Susan DePhillips
 2383 108th Street
 7/20/15

Site Plan

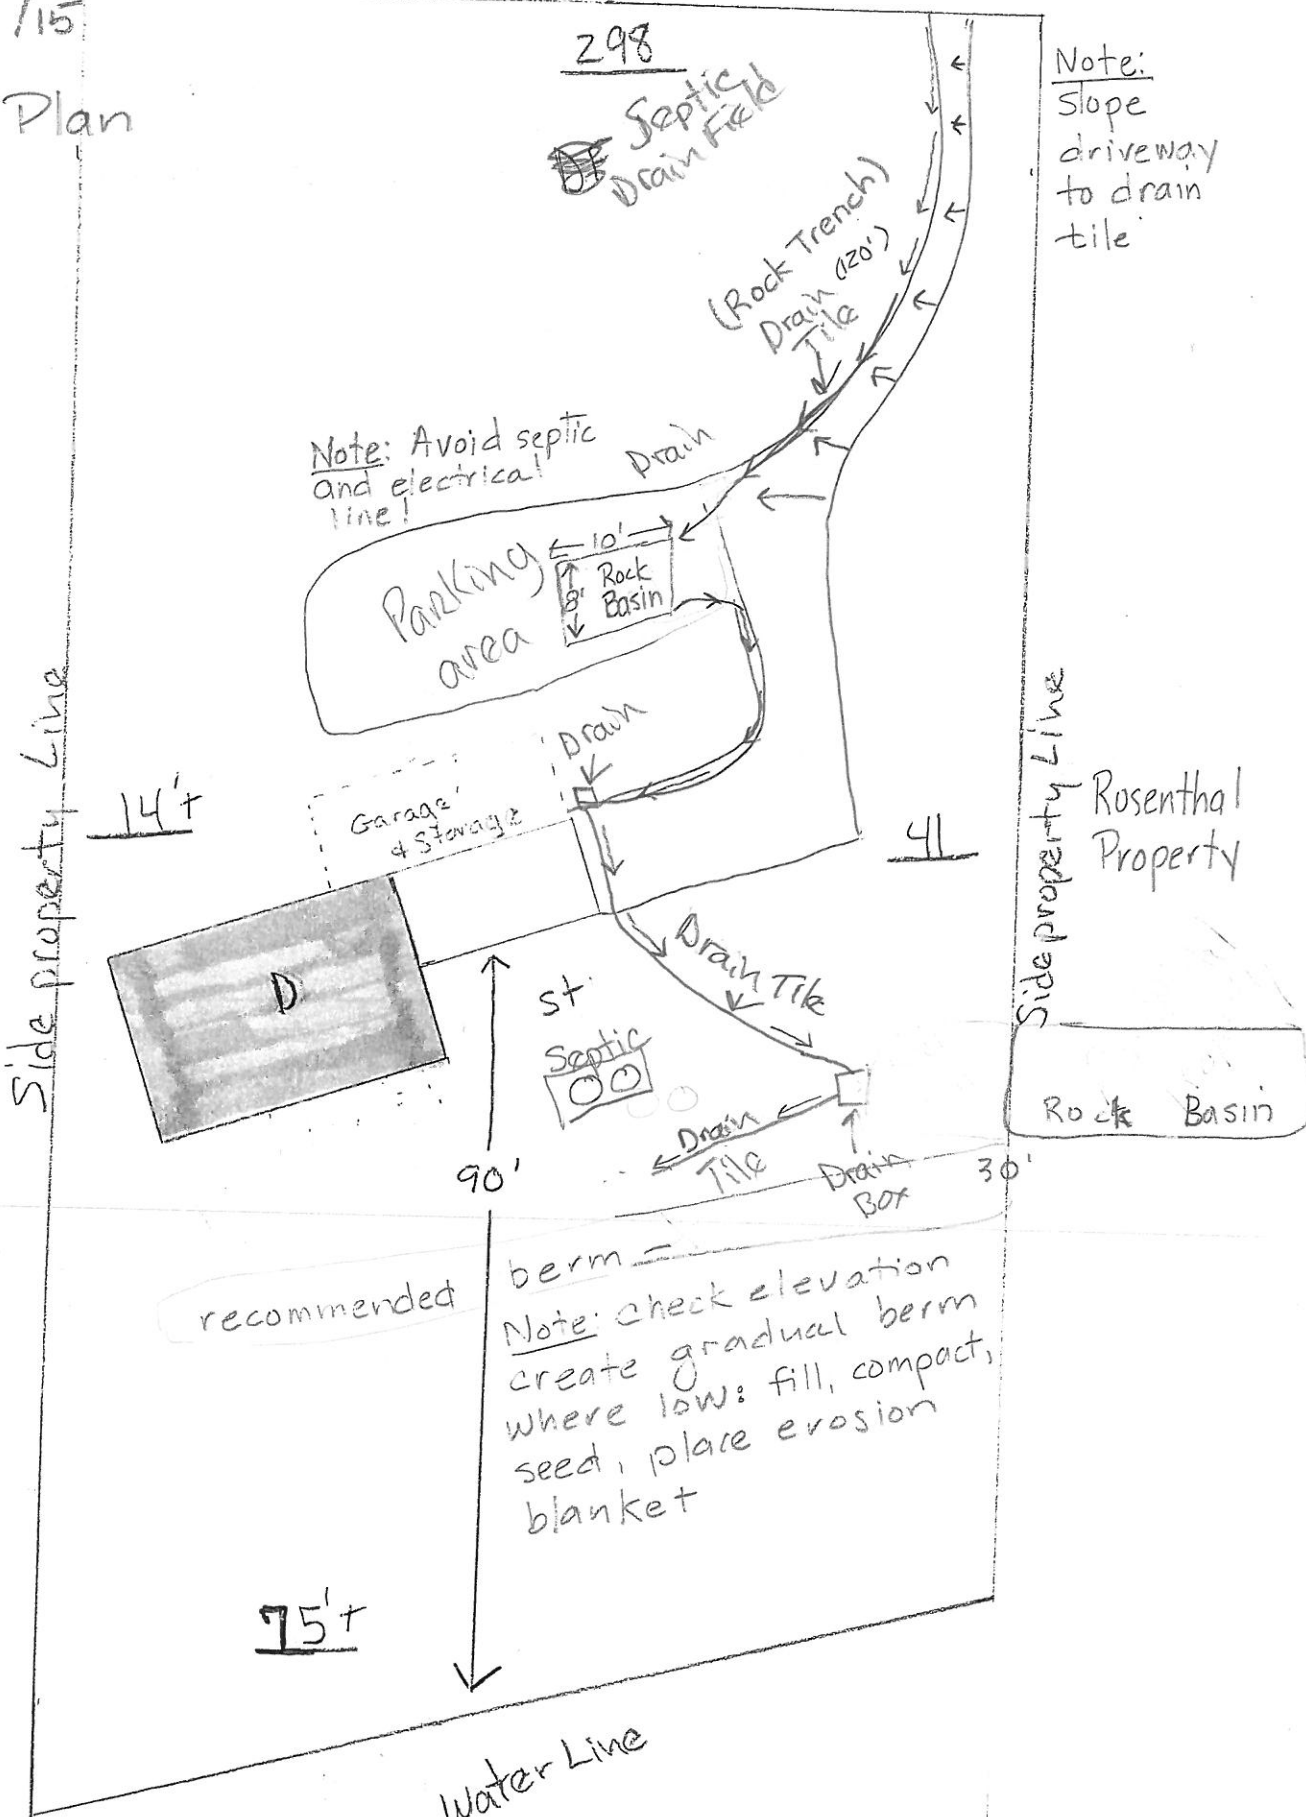
garage and addition to garage may not be attached the cabin in any fashion. SK

Note: check elevation create gradual berm where low: fill, compact, seed, place erosion blanket

Note: Slope driveway to drain tile
